Avnet PicoZed 7010/7020 Revision B Errata

3.1 Incorrect Footprint for Quad Multiplexer/ Demultiplexer

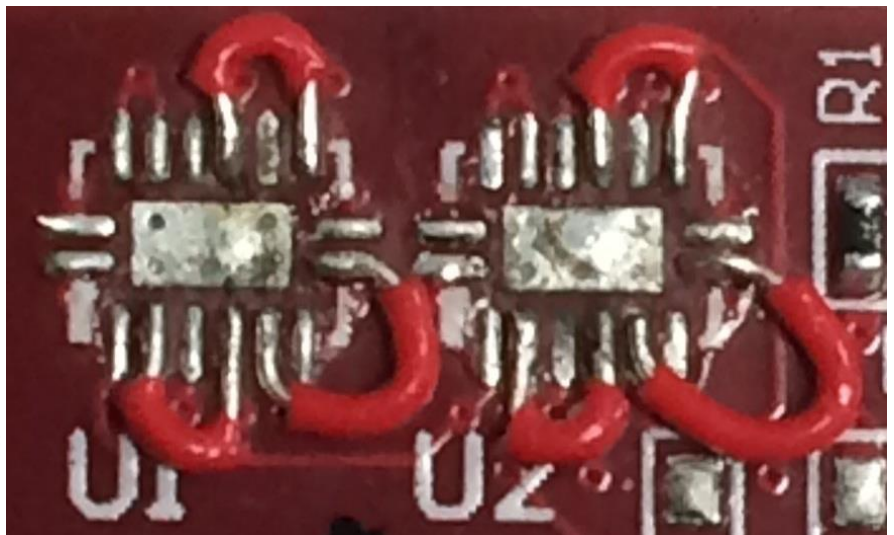
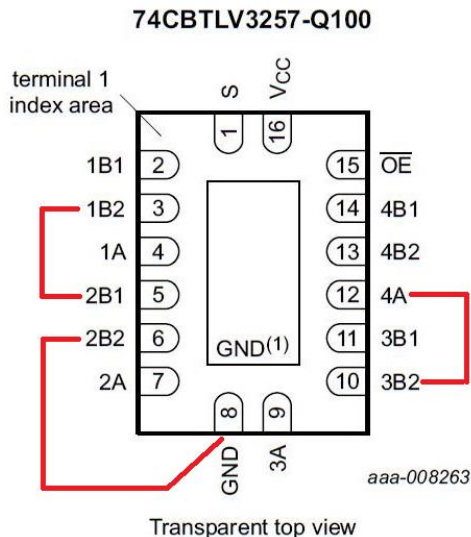
Quad Mux/Demux devices U1 and U2 on the 7010/7020 are affected by this erratum. The incorrect footprint renders the Mux/Demux circuit unusable and requires rework be performed to add in desired functionality.

Boards that have the incorrect footprint on them were reworked to install jumper wires to include the desired functionality. Avnet has chosen to make the eMMC device the default interface and has had boards reworked to ensure the functionality of the eMMC memory interface. The implementation of the eMMC interface via the jumper wires means the loss of the PS MIO interface at the JX2 connector for the Rev B boards. The customer can implement the JX2 interface if necessary by having the board optionally reworked to install jumper wires to implement the PS MIO pins to the JX2 connector. This will result in the loss of the eMMC memory interface.
